**Committee of Experts on the Transport of Dangerous Goods  
and on the Globally Harmonized System of Classification  
and Labelling of Chemicals**

**Report of the Committee of Experts on the Transport of  
Dangerous Goods and on the Globally Harmonized System of  
Classification and Labelling of Chemicals on its ninth session**

**Addendum**

**Amendments to the sixth revised edition of the Recommendations on  
the Transport of Dangerous Goods, Manual of Tests and Criteria  
(ST/SG/AC.10/11/Rev.6 and Amend.1)**

Figure 20.1 (a): Renumber to 20.1 and replace the figure with the following:

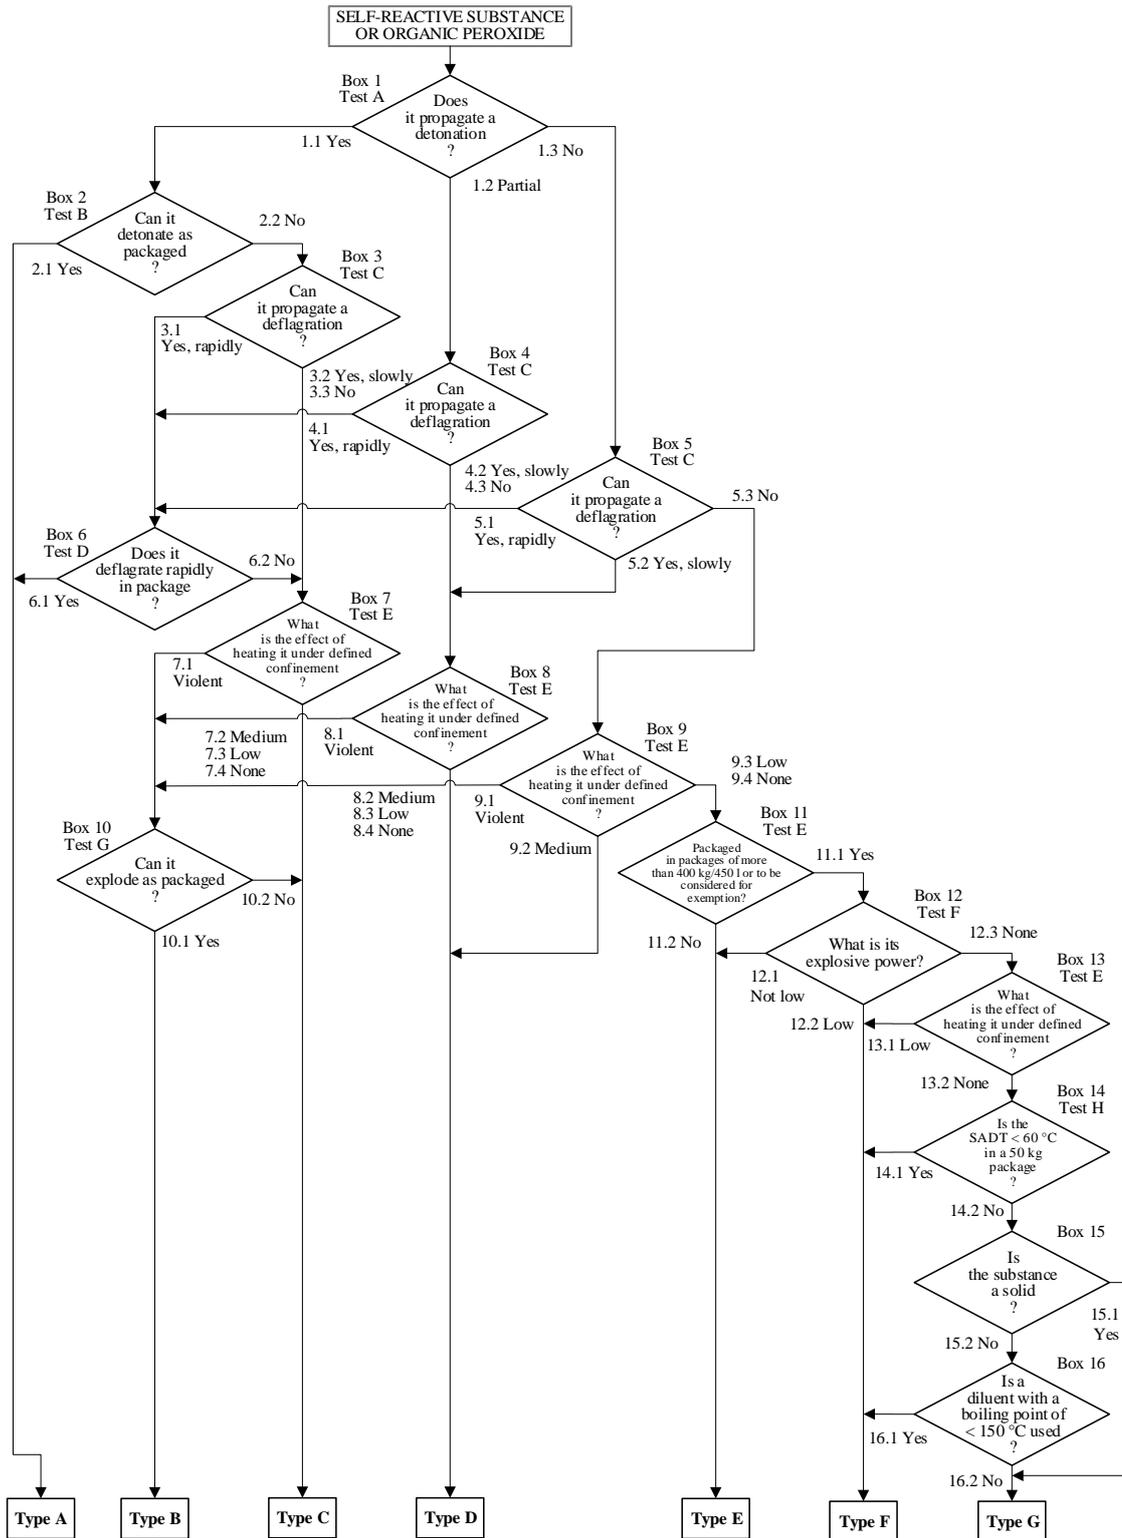
Add the following note to new figure 20.1:

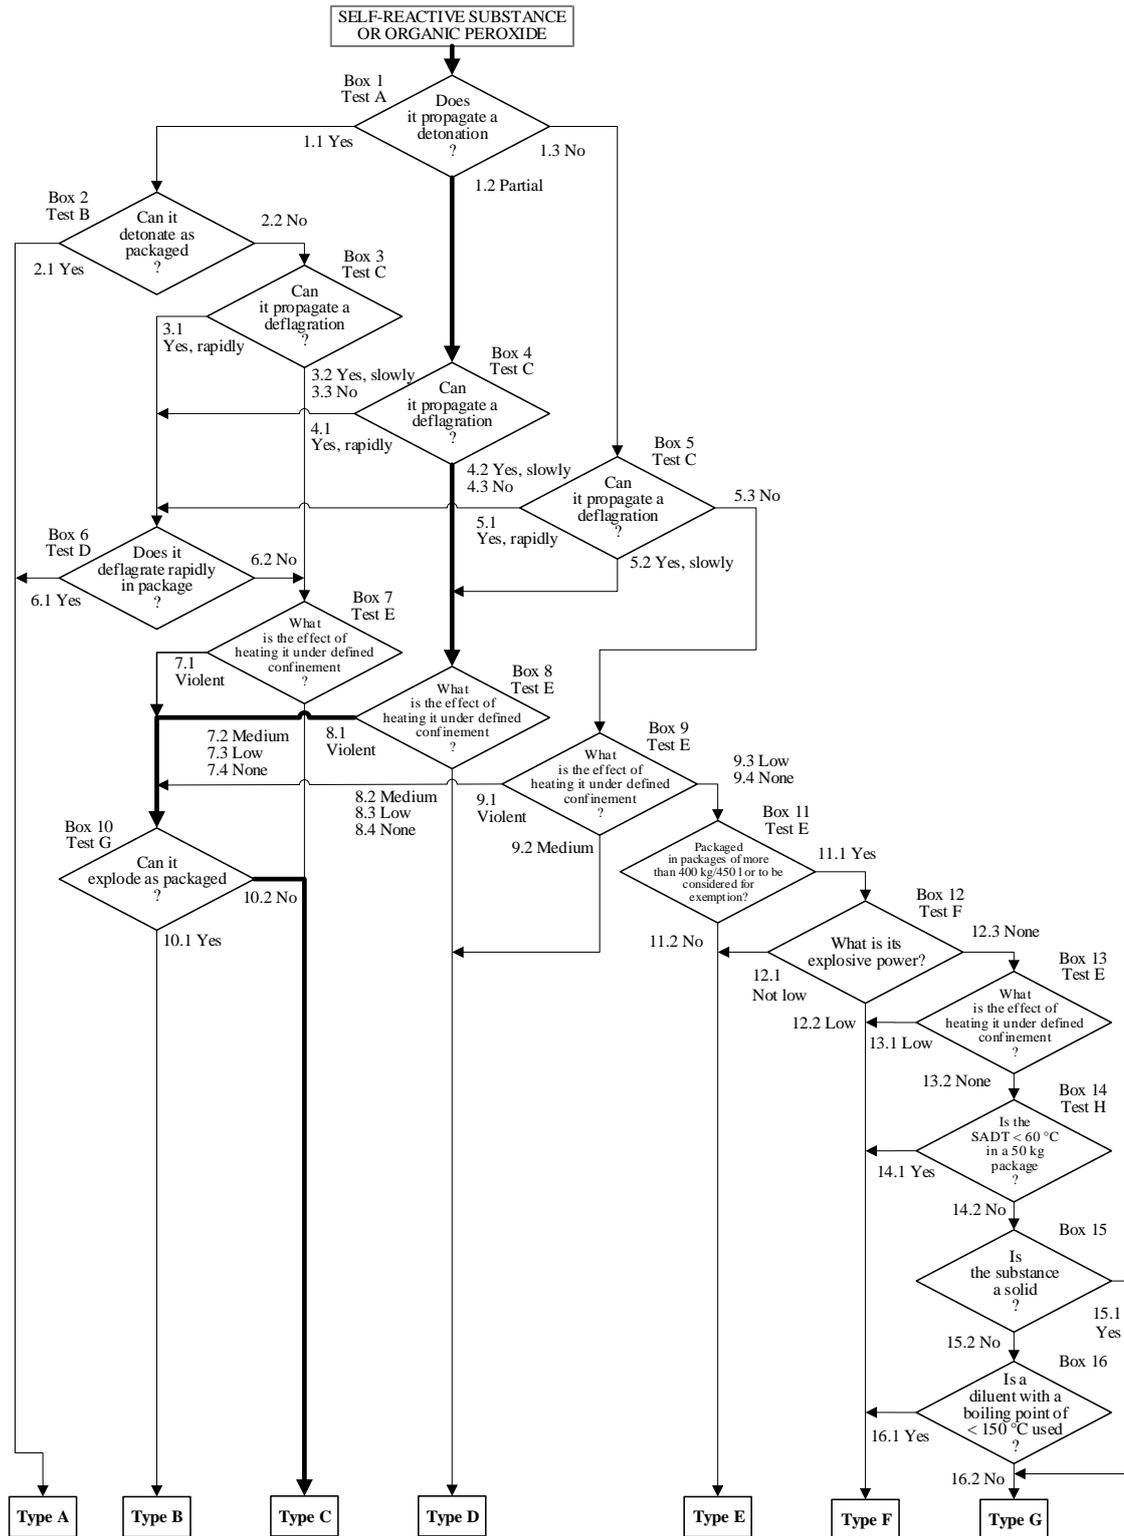
Replace the current figure 20.3 with the following:

**Figure 33.2.3: Flow chart for the classification of flammable solids, except metal powders**

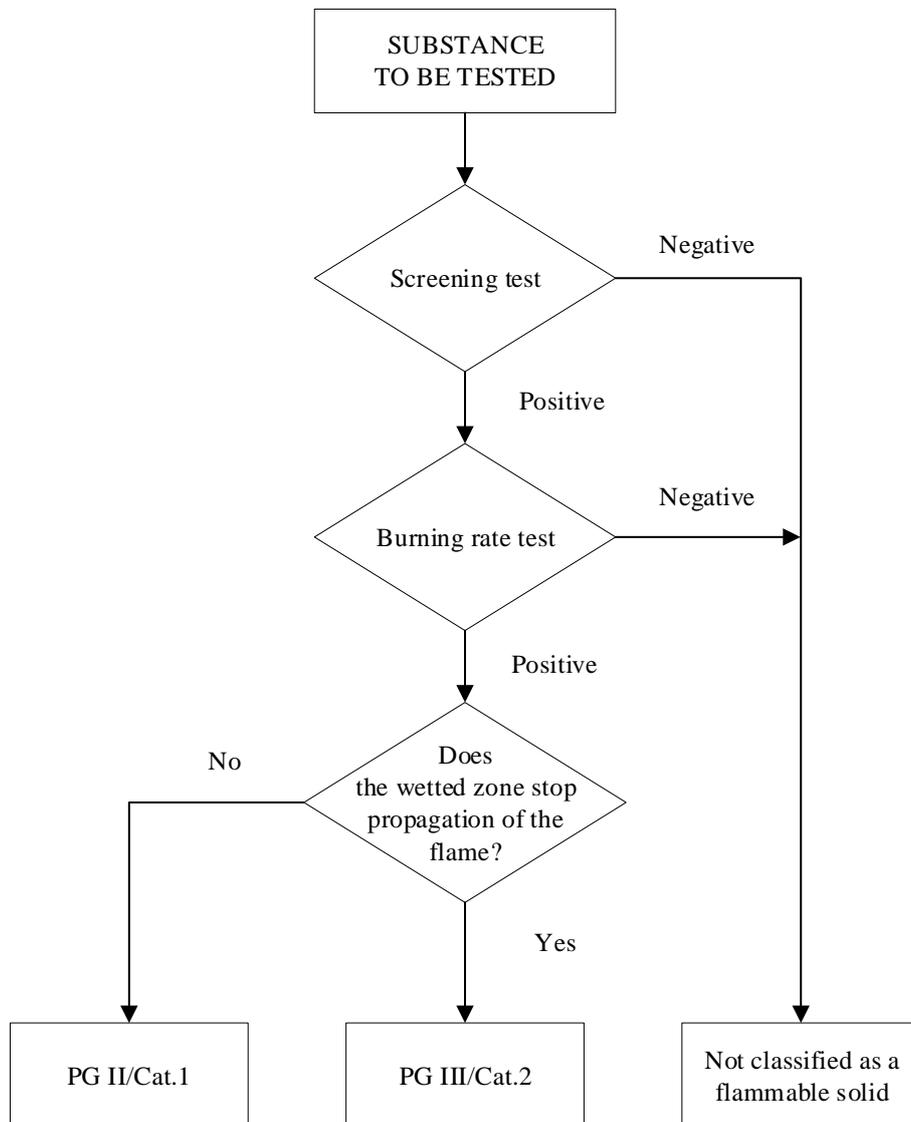
Fig. 33.2.3 (new, former 33.2.1.3) Replace the figure and it’s heading by the following:

Fig. 33.4.3.3.1 (new, former 33.3.1.3.3.1) Replace the figure by the following:

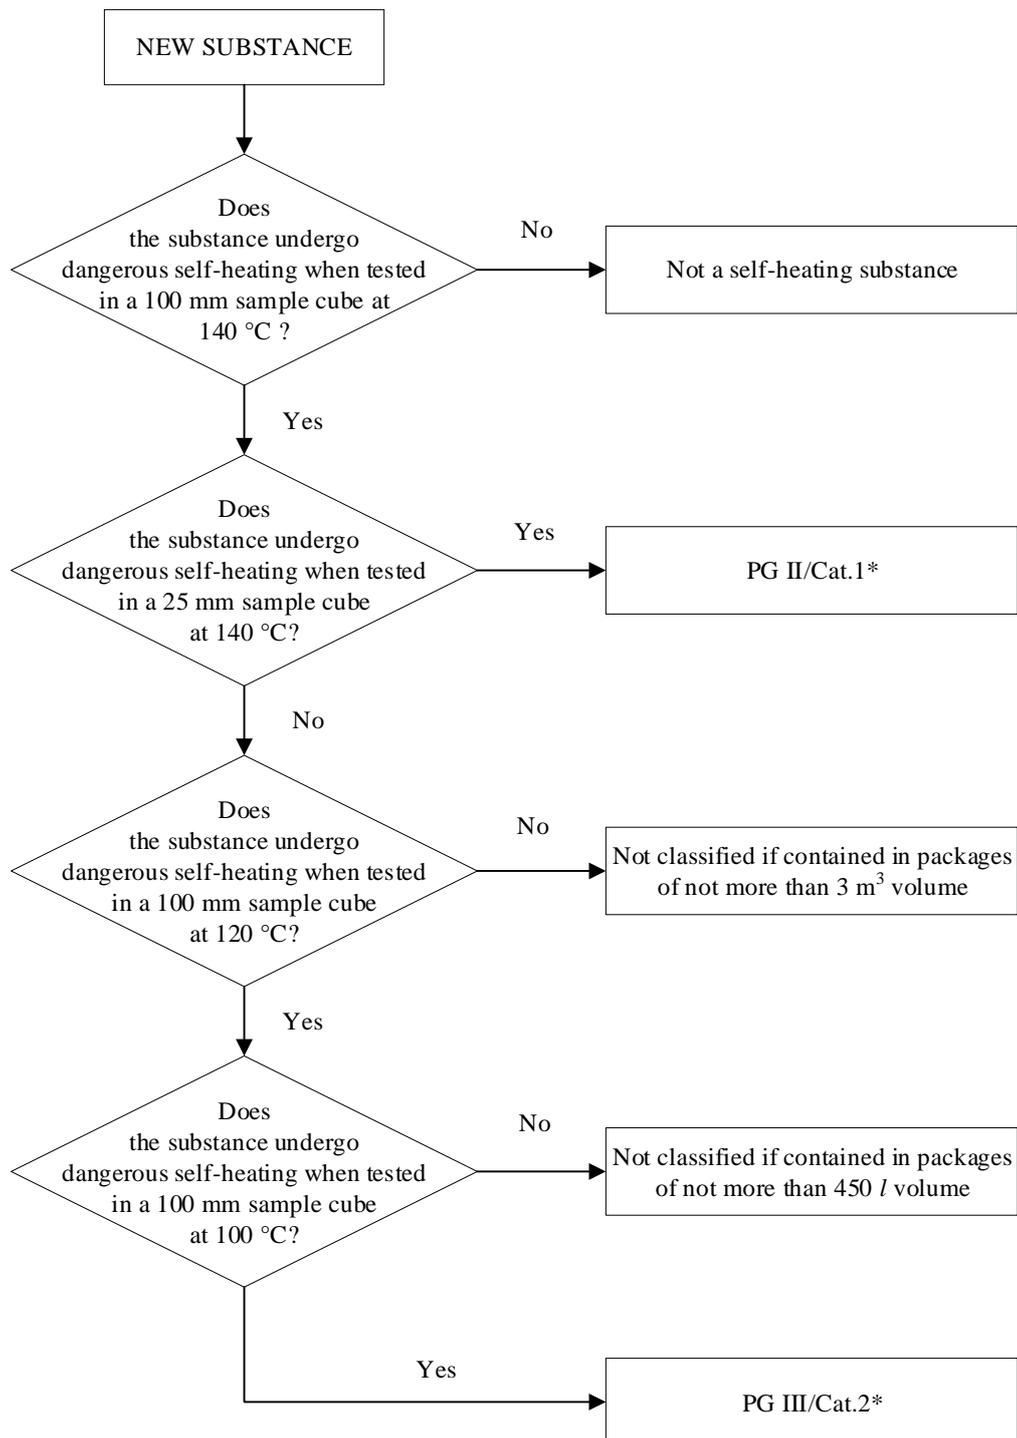
In the footnote, replace “in Division 4.2” by “as self-heating substances”.
